RE: NICHOLS PROP

COMMENTS: DUE 5/26/81

Nichols Property Sketch Plan

SKETCH PLAN
NICHOLS PROPERTY
TAX MAPS 28 & 34 PARCEL 1
5th Election District
Howard County, Maryland

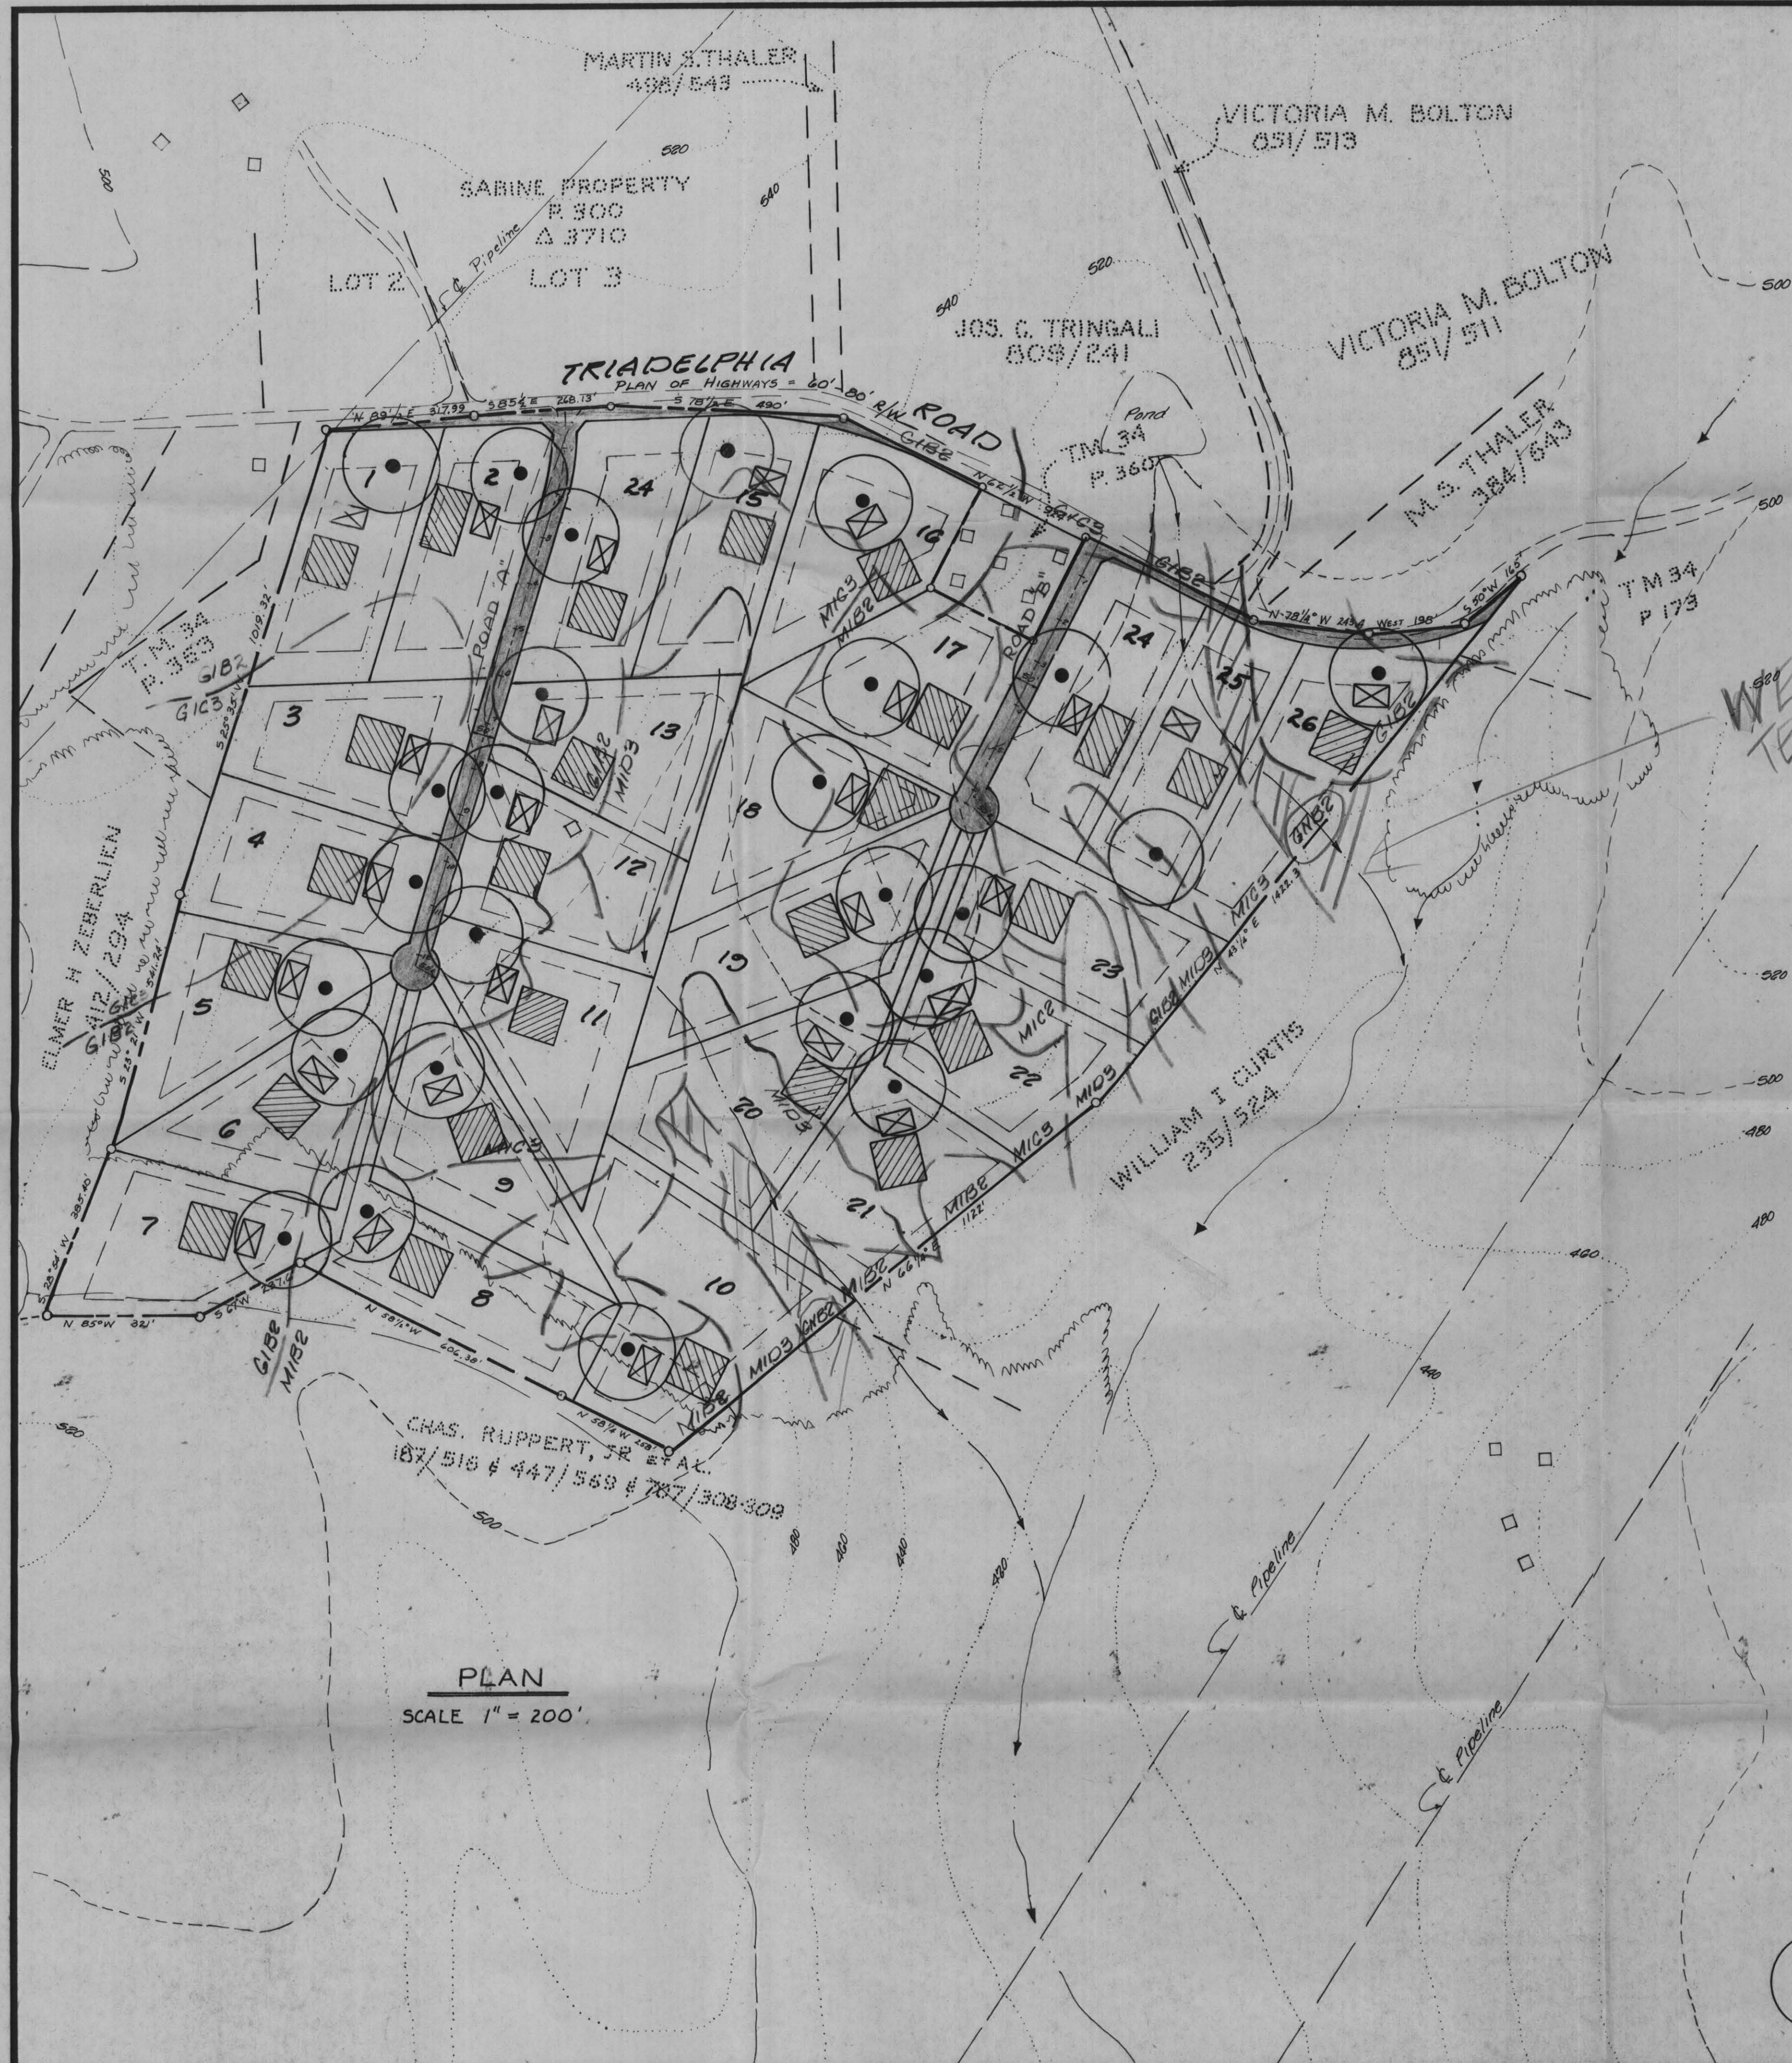
Prior to our review & comments a sketch plan with 2 foot contour is required; no percolation test application can be accepted without it.
